**Addendum No. 3**  
**April 23, 2026**

Project: **SOUTHEAST TECHNICAL COLLEGE HOUSE CONSTRUCTION LAB**  
Sioux Falls, South Dakota  
Architecture Incorporated Project No. 3155

Scope of this Addendum:

**DEMOLITION SITE PLAN - ELECTRICAL**  
SCALE 0 10 20 30 40

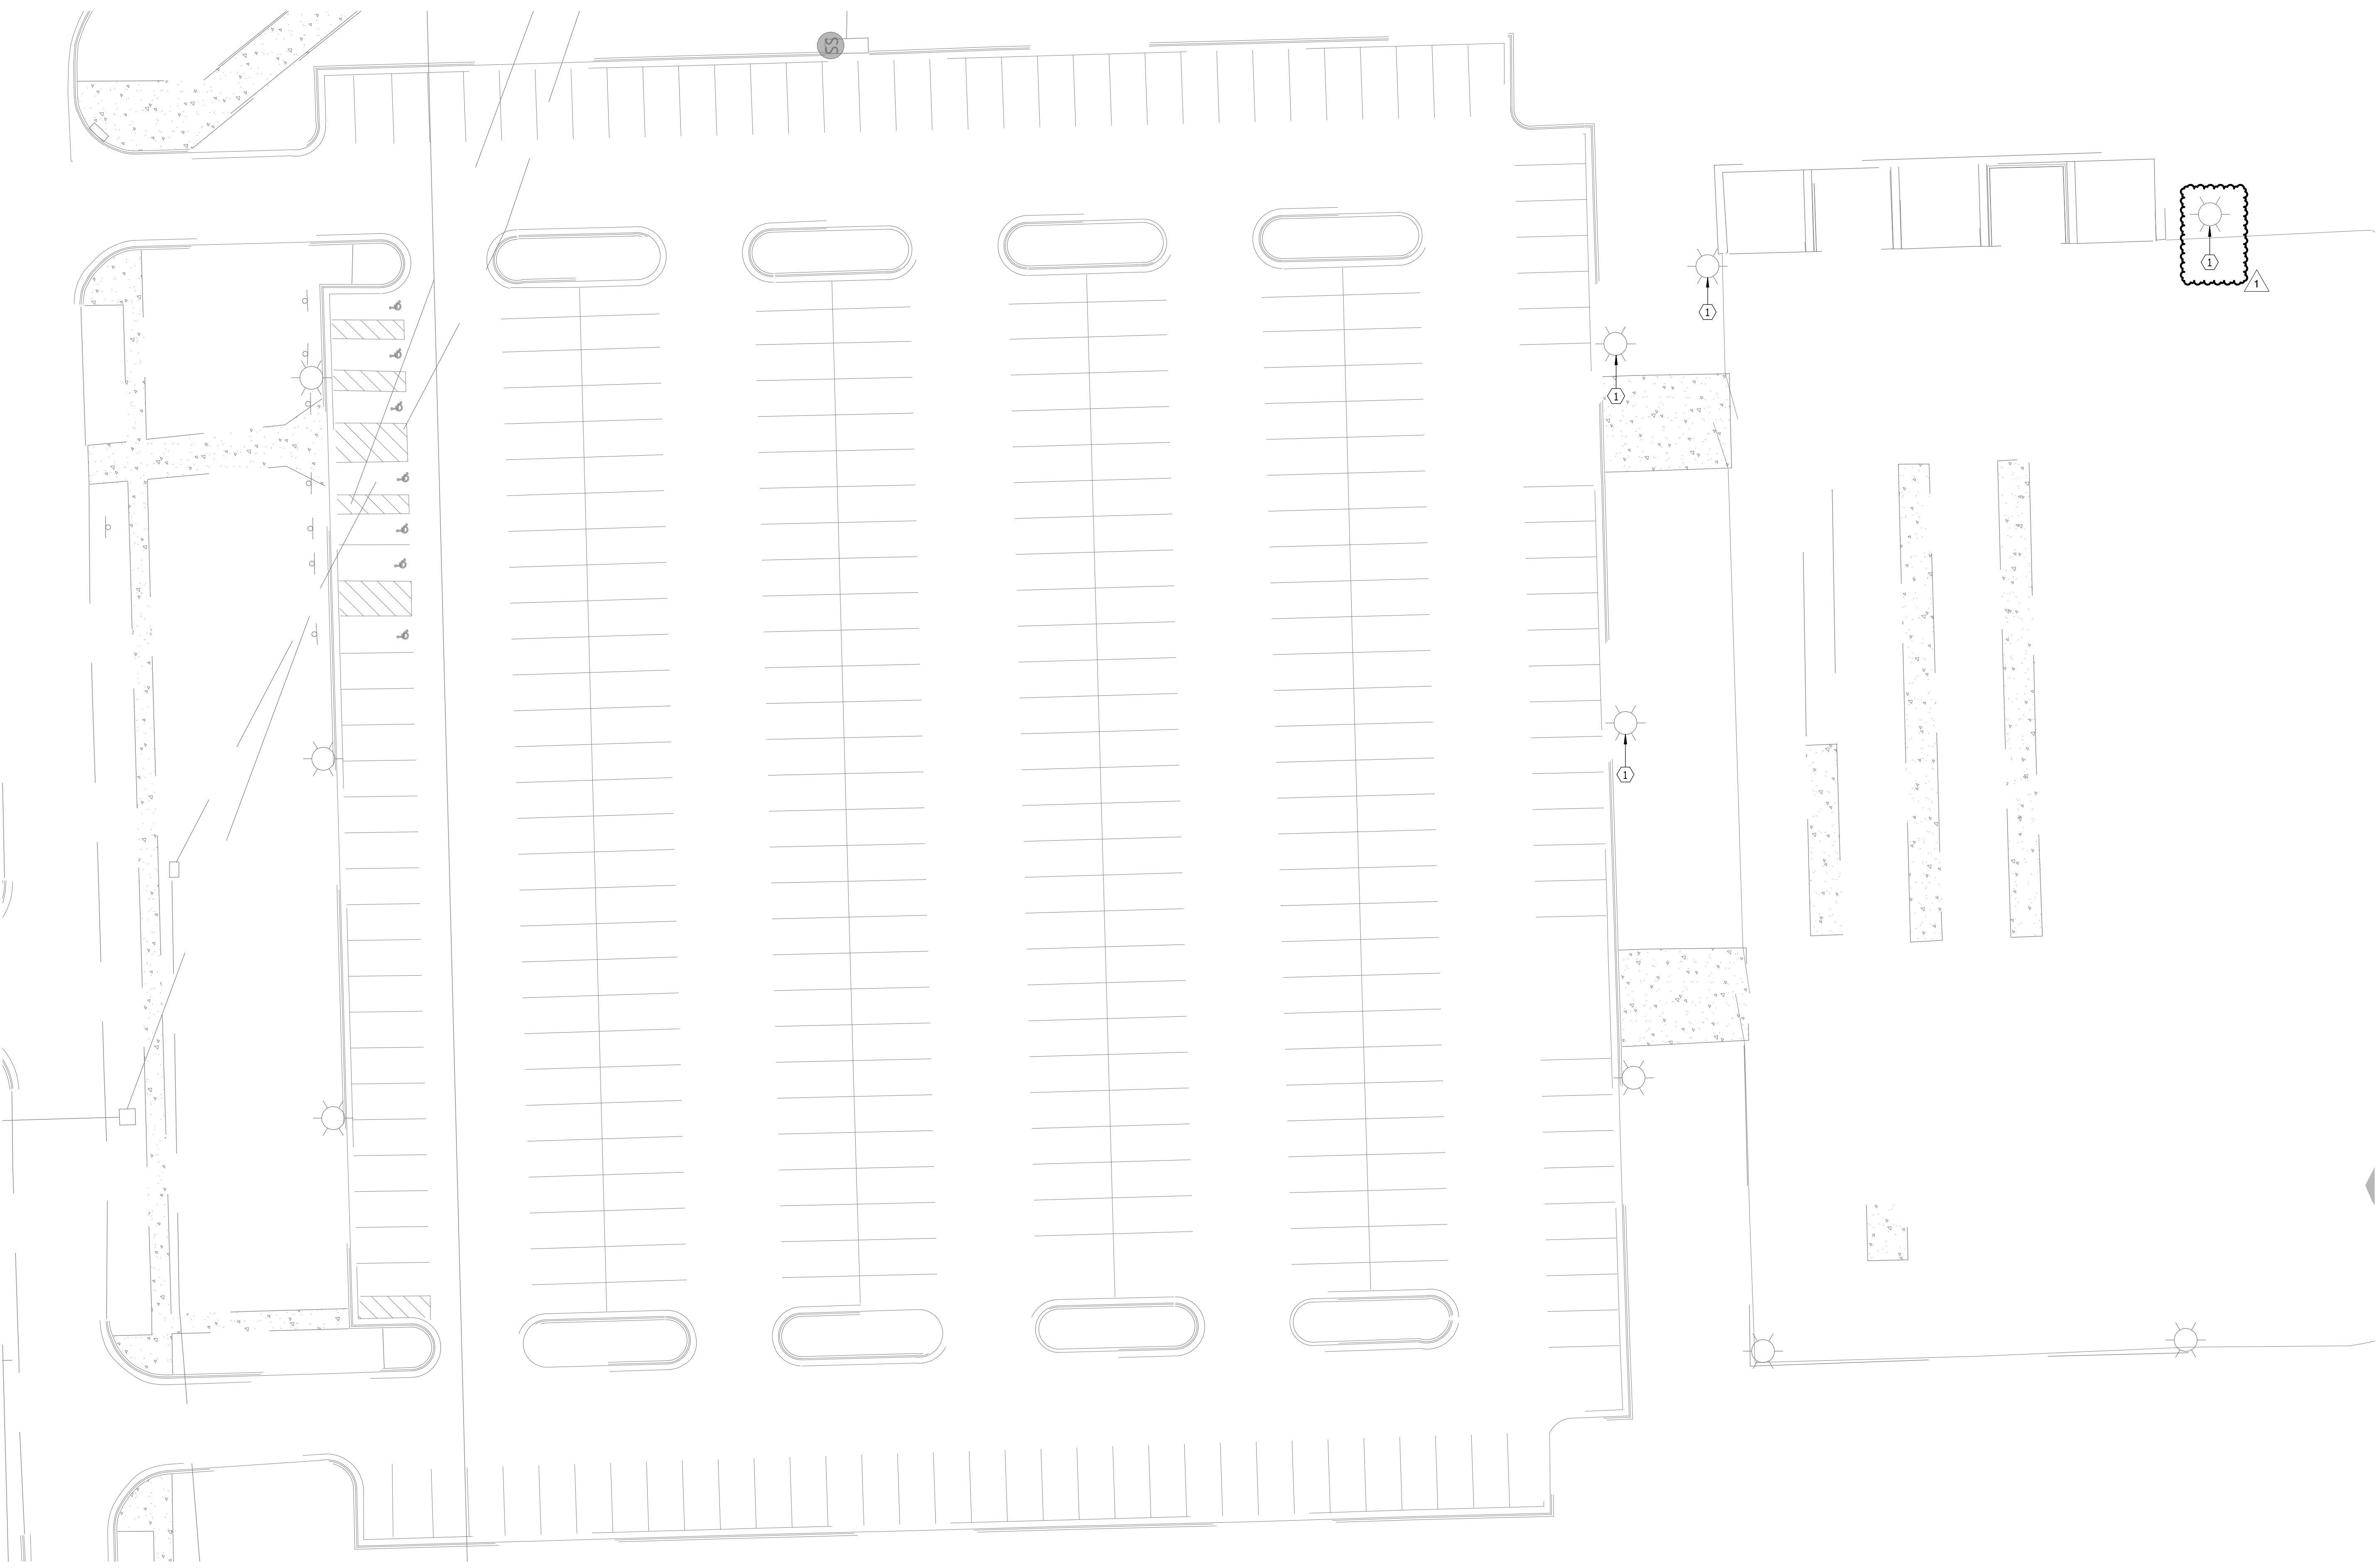
1) SHEET 9.00 – DEMOLITION SITE PLAN - ELECTRICAL

- a) In reference to Electrical Note Number 1, remove “**Salvage to Owner**”. The electrical contractor will be responsible for proper disposal.
- b) Add one additional pole light on the southeast corner of the property with Electrical Note #1 tag as shown per *revised* electrical drawing Sheet 9.00, *revision* dated 4-22-2026; see *revised* electrical drawing attached to the end of this addendum.

**SERVER 104 ENLARGED - BASE BID ELECTRICAL**  
 SCALE 0 1 2 3 4

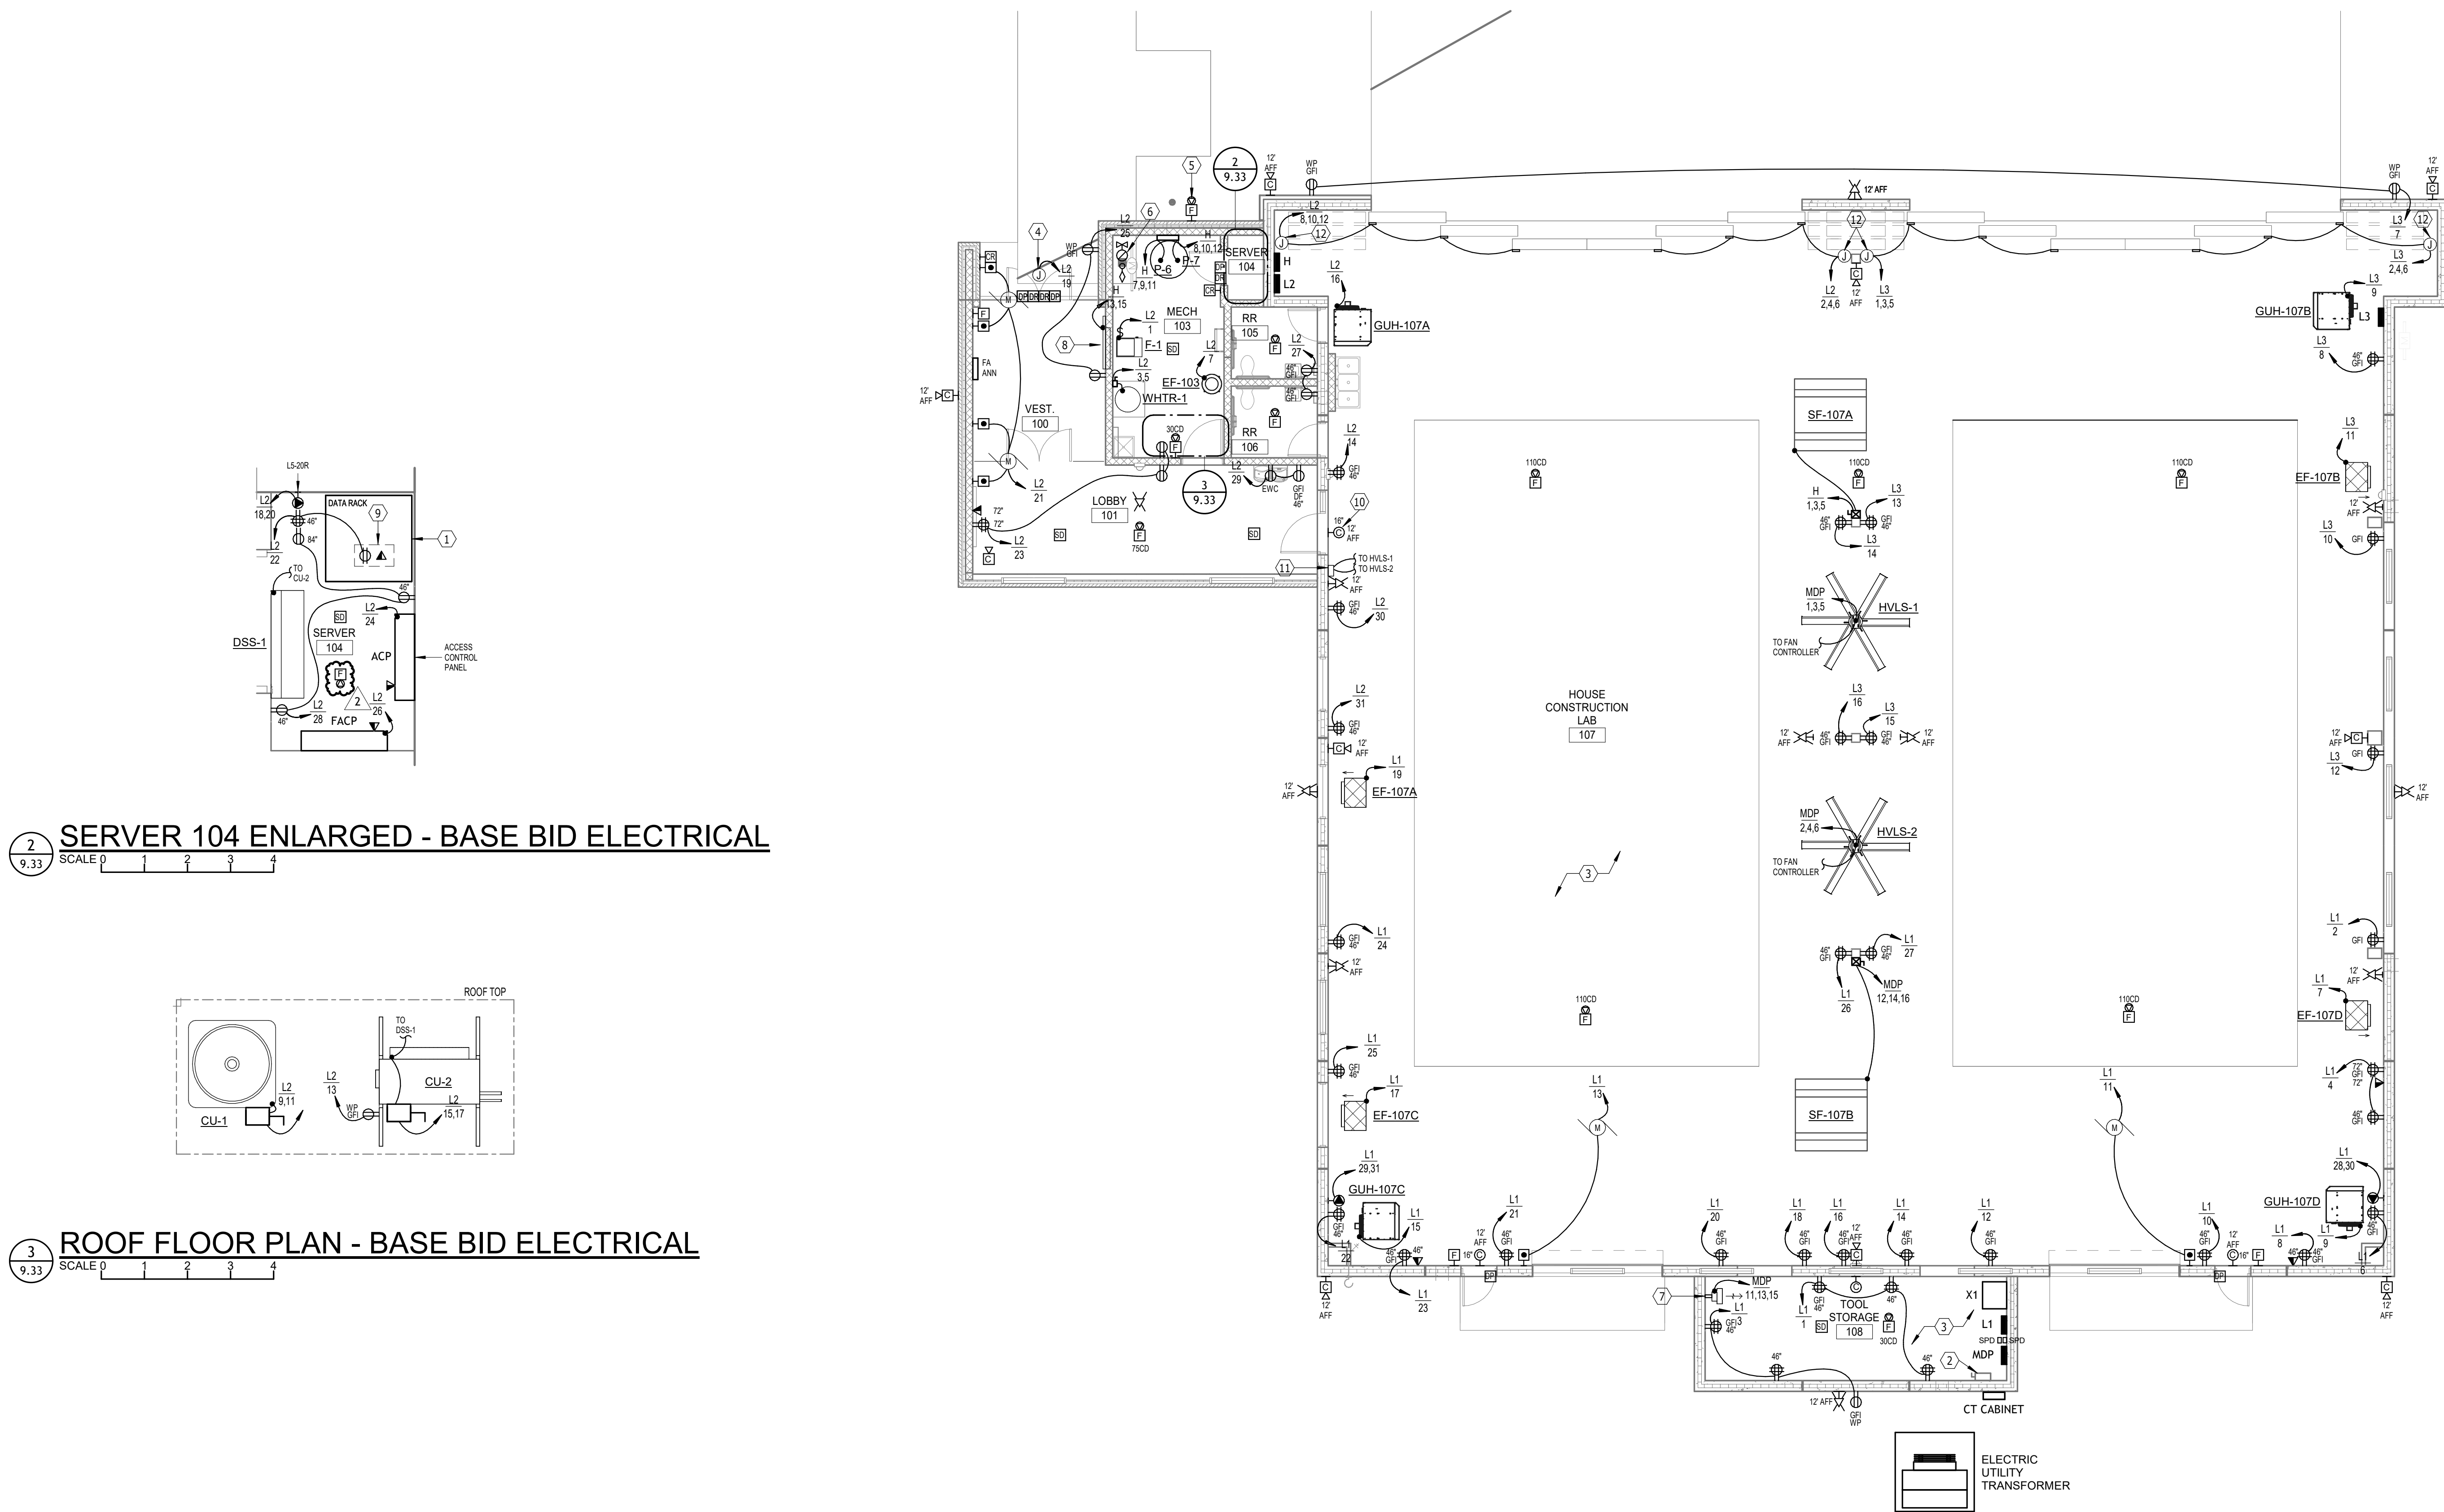
2) SHEET 9.33 – MAIN FLOOR PLAN – BASE BID ELECTRICAL

- a) In reference to Server 104 enlarged detail, add FA notification appliance in Server 104 as shown per *revised* electrical drawing Sheet 9.33, *revision* dated 4-22-2026; see *revised* electrical drawing attached to the end of this addendum.
